## **Appendix B1: Flood modelling evidence of Mr Alistair Osborne**

**Statement of evidence of Alistair Osborne on behalf of Hutt City Council  
(Flood Hazard Modelling)**

**Date: 20<sup>th</sup> July 2026**

**22.1 Adrian Palmer Family Trust (315) - Various**

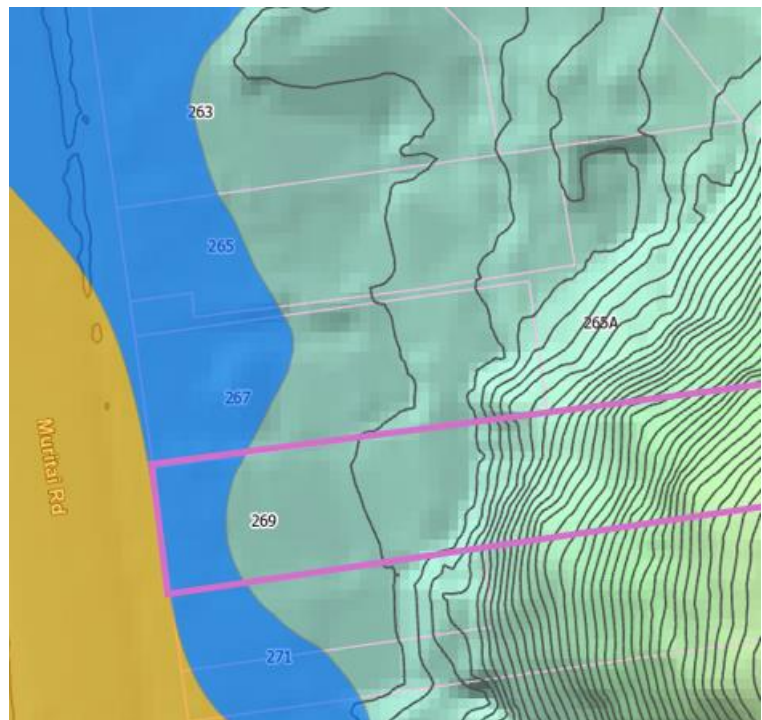
- The submitter opposes the flood hazard overlays mapped on 18 locations owned by the submitter. No reasons or evidence is provided in support of removing the flood hazard overlays. A review of the locations shows that the modelled flooding is reasonable/expected given the event simulated
- I recommend the flood hazard overlays remain unchanged at the locations specified in the submission.

**22.8 Beverley and Oliver Driver (242) - 57A Hautana Street, Woburn**

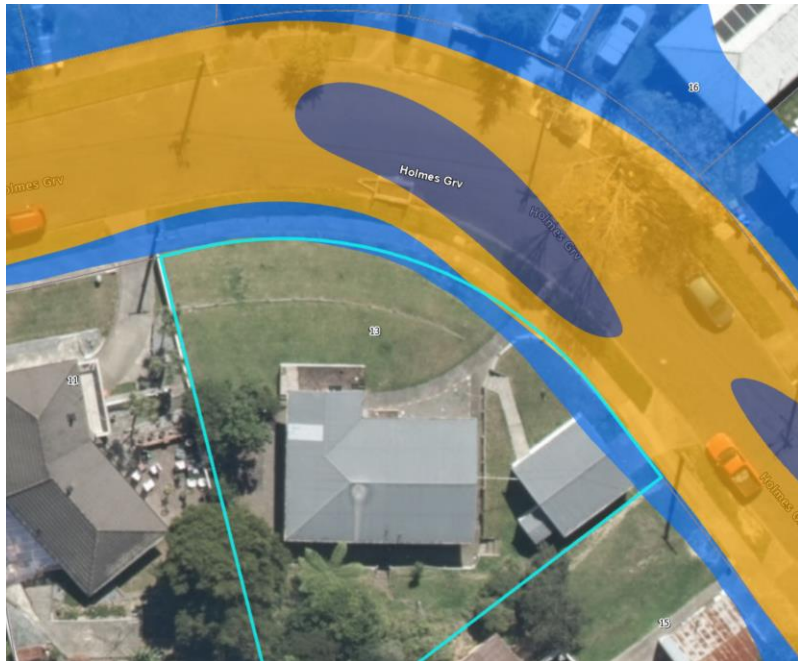
- The submitter opposes the high flood hazard overlay mapped on their property, highlighting local topography and no previous flooding
- Please see Sections 20.1 and 20.2.
- Further, the high flood hazard overlay is present on the submitter’s property due to the stream (and represented stream corridor) at the rear of the property.
- I recommend the flood hazard overlays remain unchanged at the location specified in the submission.

Current PDP flood hazard overlays (464)

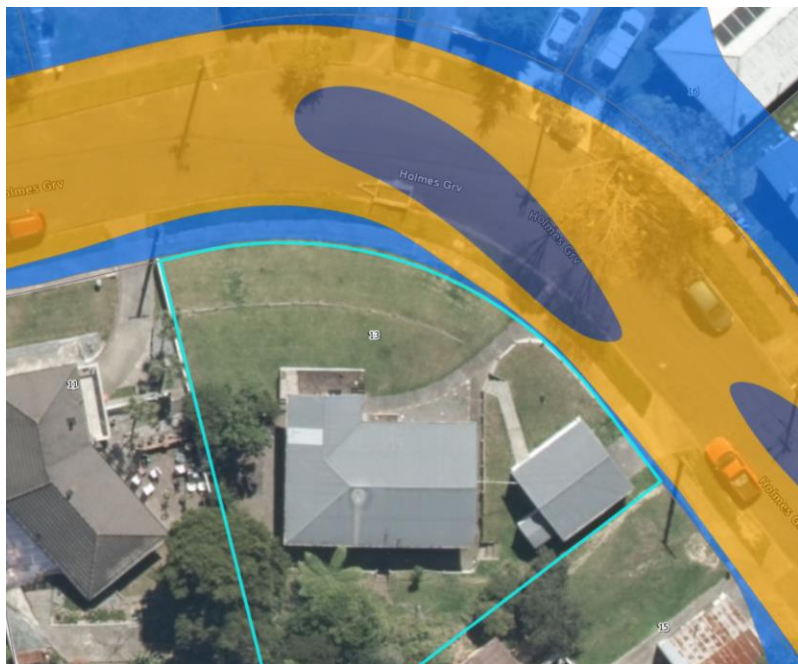
- The submitter supports with amendments the flood hazard overlays in the vicinity of their property. They requested that the overlays are refined based on the site photographs showing a retaining at the edge of the property would contain the flooding within the road parcel.
- I have reviewed the location of the property in the modelling and the flood hazard overlays and note that property is intersected by the flood hazard overlays due to the processing of the flood hazard overlays to smooth them, rather than modelled flooding extending onto the property.
- As a result, and with consideration of the site photographs, I believe it is acceptable to edit the flood hazard overlays to sit within the road parcel at this location.
- Below are images of the current and proposed flood hazard overlays

Proposed update to PDP flood hazard overlays (464)

Current PDP flood hazard overlays (392)

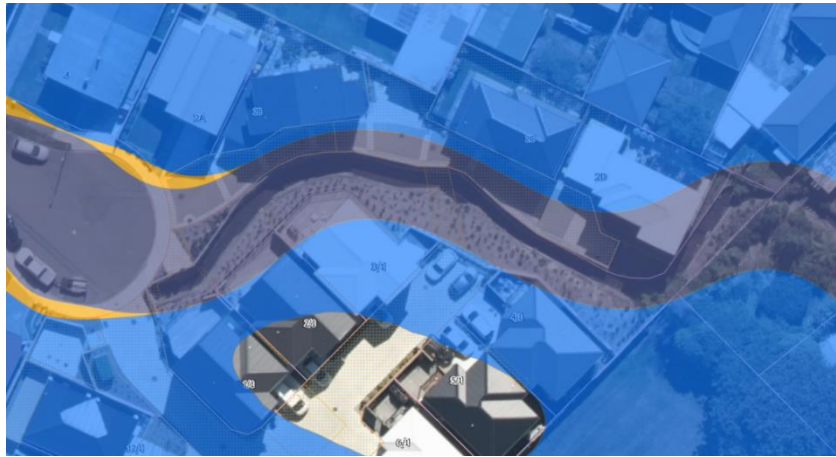
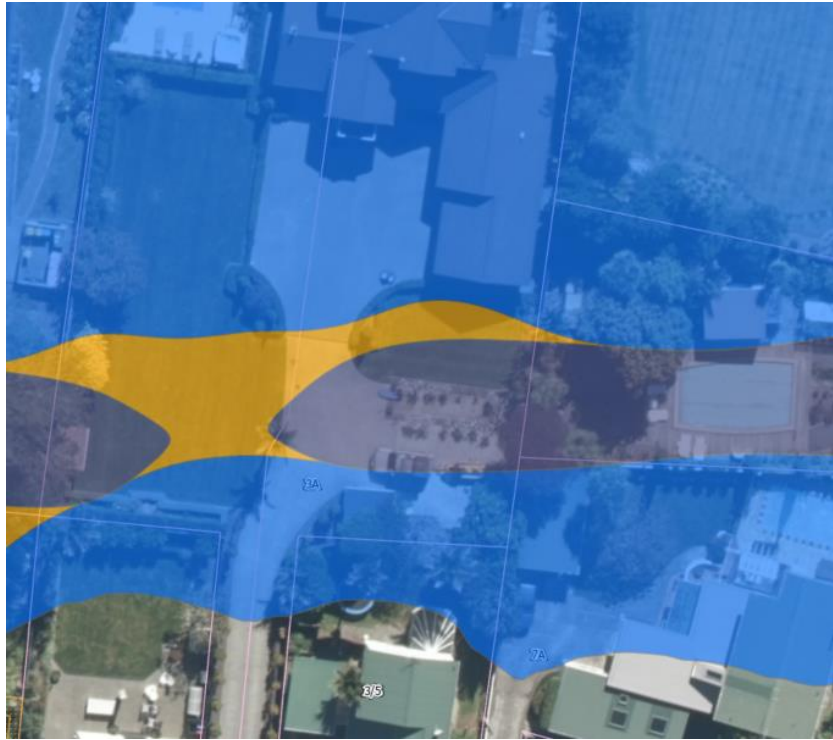
- The submitter raises multiple concerns. Issues relating to the flood hazard overlays are listed below:
  - Flooding is caused by stormwater infrastructure deficiencies rather than natural flooding.
  - The hydraulic models contain assumptions and limitations that reduce reliability.
- Please see Sections 20.3 and 20.4.
- In addition to the above, the submitter has also noted the flood risk associated with the Hutt River and work done to mitigate this risk.
- I am unable to provide comment on this as the modelling and mitigation work has been carried out by GWRC, and I am not familiar with it. However, Tiaki Wai modelling also indicates there is potential for flooding originating from the Western Hills above Manor Park.
- I recommend the flood hazard overlays remain unchanged at the location specified in the submission.

Proposed update to PDP flood hazard overlays (392)

Current PDP flood hazard overlays (448)

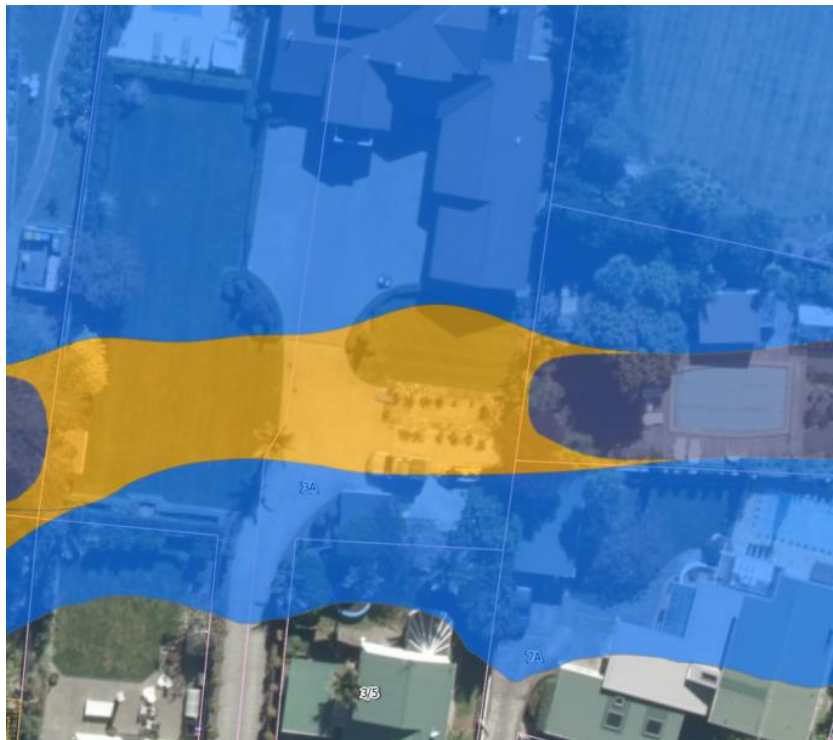
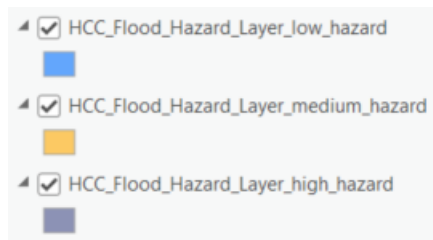
- The submitter opposes the flood hazard overlays mapped on their property for the following reasons.
  - Lack of historical flooding.
  - Climate change assumptions are excessive or unrealistic.

Proposed update to PDP flood hazard overlays (448)

**22.70 PBJ Properties Ltd (476) - 23 Fitzherbert St, Petone**

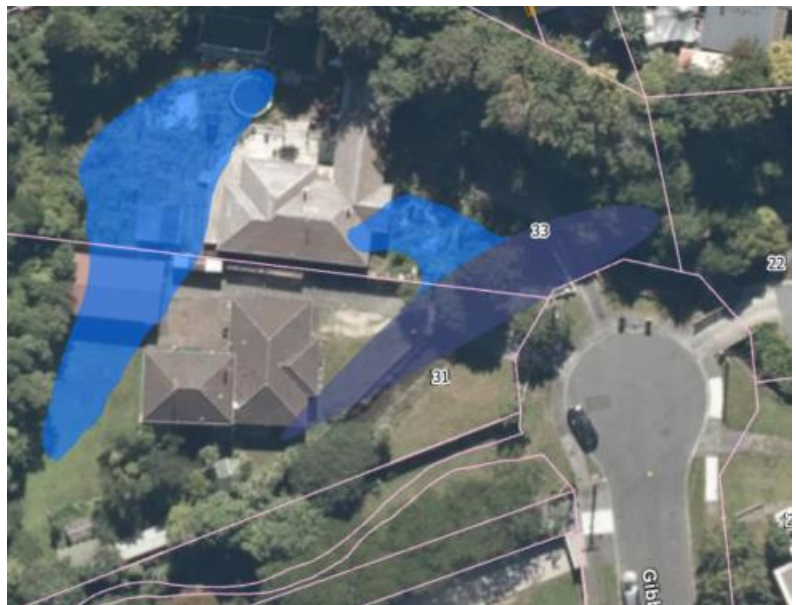
- The submitter opposes the high flood hazard overlay area on their property, asking what the documented evidence is for the decision to categorise the area as such, and why these specific areas are targeted.
- The extent of high flood hazard overlay has been set by hydraulic modelling and the Flood Hazard Planning Guidelines, both of which have associated documentation published for them. Further, areas have not been targeted, but rather have been identified through hydraulic modelling.
- I recommend the flood hazard overlays remain unchanged at the location specified in the submission.

Current PDP flood hazard overlays (145)

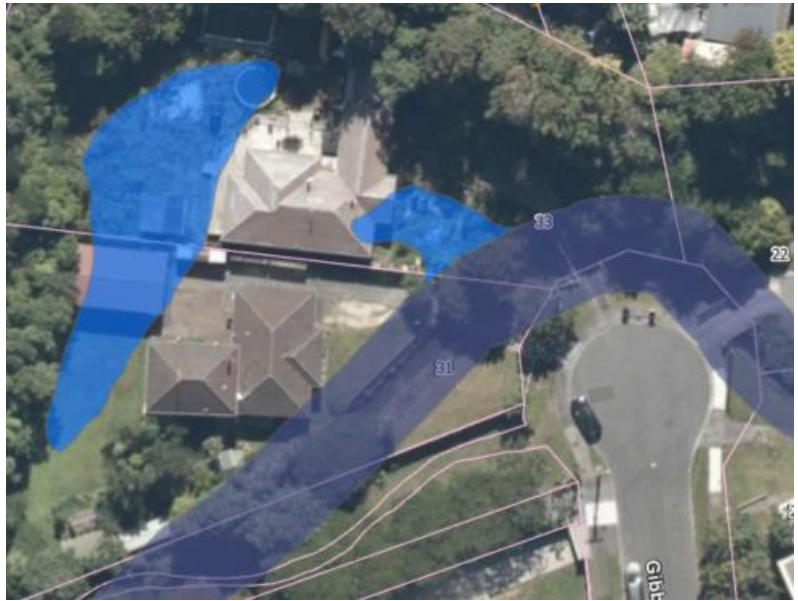
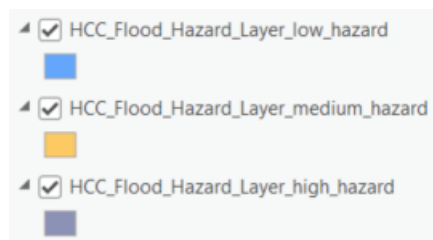
- However, I have reviewed the location of the submitter's property relative to the flood hazard overlays and note there is an error in the flood hazard overlays at this location as they do not include the full extent of the stream described in the submission (see Section 21).
- I recommend the flood hazard overlays are updated to include the missing stream corridors. In the interim, I recommend the flood hazard overlays remain unchanged.
- Below are images of the current flood hazard overlays and the recommended update including stream corridors.

Recommended inclusion of a stream corridor in the PDP flood hazard overlays (145)

Current PDP flood hazard overlays (463)

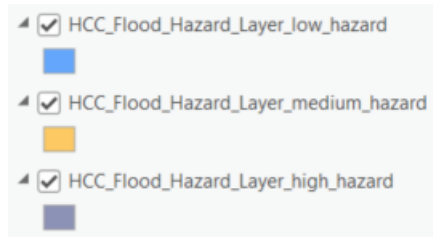
- The submitter opposes the flood hazard overlays mapped on their property because of a lack of historical flooding and the representation of a small stormwater drain as being high hazard.
- Section 20.1 provides commentary on the lack of historical flooding.

- I have reviewed the submitter's property in the flood model and the flood hazard overlays.
- The high flood hazard overlay is only present because the short stormwater drain in the reserve adjacent to the submitter's property has been designated as a stream corridor.
- I agree with the submitter that this drain should not represent a stream corridor, and the model results in the area do not reach depths or speeds that would be classified as high or medium hazard as per the hazard classification guidance document.
- I recommend removing the high flood hazard overlay at this location and replacing it with the low hazard overlay.
- Below are images of the current PDP flood hazard overlays and proposed updates relative to this submission.

**22.76 Richard Kemp and Honor Kemp (25) - 226 Marine Drive, Lowry Bay**

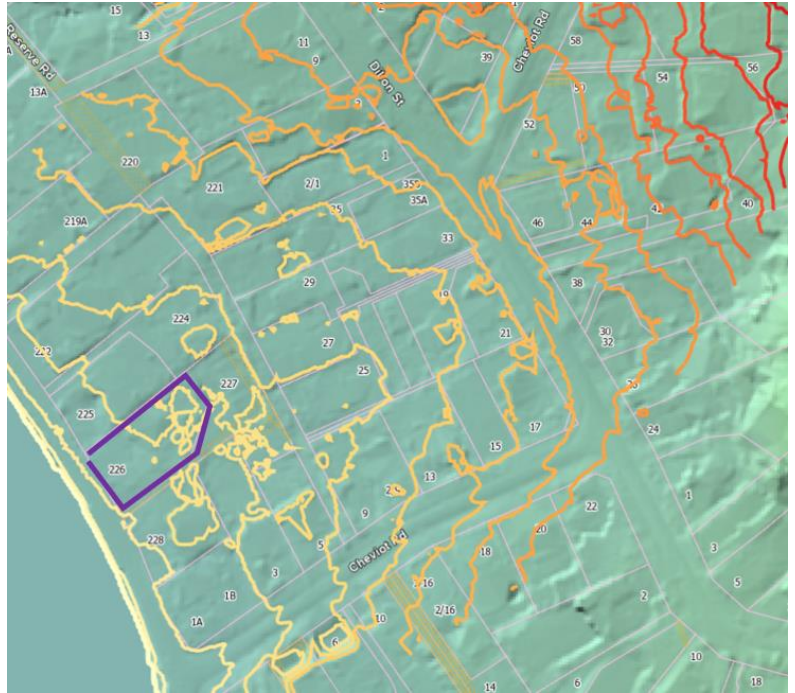
- The submitter states that their property has not previously been affected by flooding, noting that there are no watercourses nearby that could give rise to flooding.
- Please see Section 20.1 regarding the non-occurrence of historical flooding.
- A review of the hydraulic modelling indicates flooding at the site is generated from runoff from the hill catchment above Cheviot Rd.
- Further, a review of available topographic contours shows that the property and adjacent properties sit in a low point in the catchment the was likely the old flow path for runoff draining from the hills.
- The image below shows the location of the property relative to the topographic contours (themed by decreasing elevation).

- I recommend the flood hazard overlays remain unchanged at the location specified in the submission.

Current PDP flood hazard overlays (352)

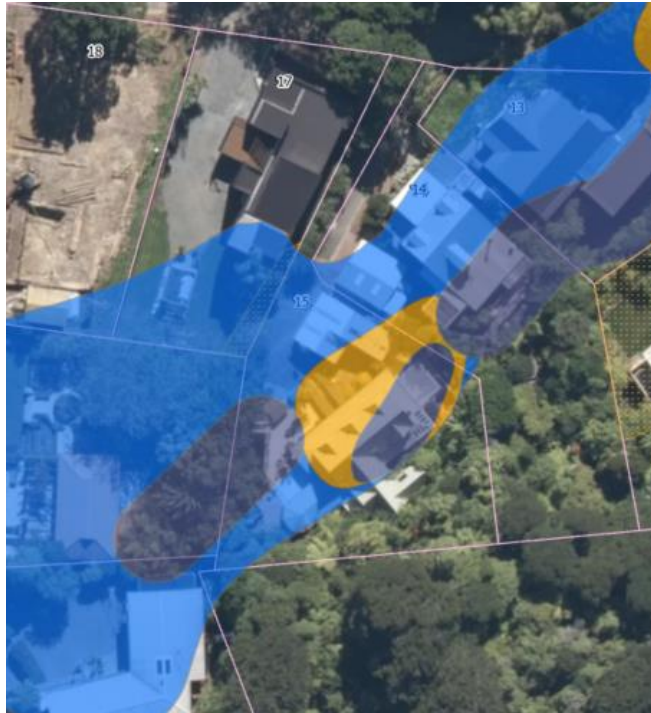
- The submitter opposes the high flood hazard overlay mapped on their property for the following reasons:
  - A lack of historical flooding.
  - Climate change assumptions are excessive or unrealistic.
- Please see Sections 20.1 and 20.5 for commentary on these issues.
- In addition to the above, the submitter also notes the high flood hazard overlay associated with the stream corridor is only restricted to their property, while in

- I have reviewed the relevant hydraulic model and can confirm there is an error in the flood hazard overlays at this location as they do not include the full extent of the stream described in the submission and represented in the model (see Section 21).
- I recommend the flood hazard overlays are updated to include the missing stream corridors. In the interim, I recommend the flood hazard overlays remain unchanged.
- Below are images of the current flood hazard overlays and the recommended update including stream corridors.

Recommended inclusion of East Harbour stream corridors in the PDP flood hazard overlays (352)

**22.81 Stephen Flaunty (34) - 121 Waterloo Road, Hutt Central**

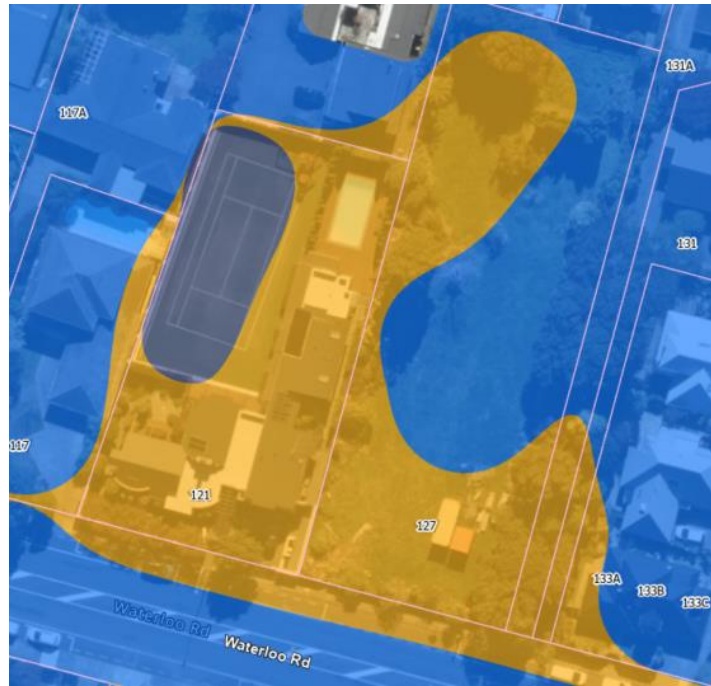
- The submitter opposes the flood hazard overlay mapped at their property for the following reasons:
  - A lack of historical flooding.
  - The flood modelling is inaccurate.

- Property-specific mitigation has not been recognised.
- Please see Sections 20.1, 20.4, and 20.6 for commentary on these issues.
- A review of the model results show flooding arrives at the property from upstream of the property. The high flood hazard shown over the tennis court is due to modelled topography showing this area as lower than the adjacent ground. As a result, the modelled flooding is deeper as it crosses the tennis court, leading to the high hazard classification.

Current flood hazard overlays (423)

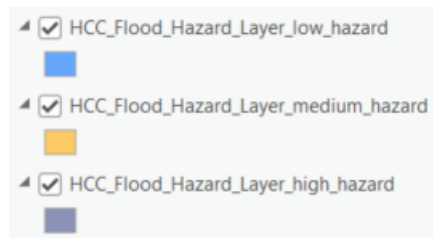
- Below are images of the current flood hazard overlays and the recommended update including stream corridors.

Recommended inclusion of East Harbour stream corridors in the PDP flood hazard overlays (423)
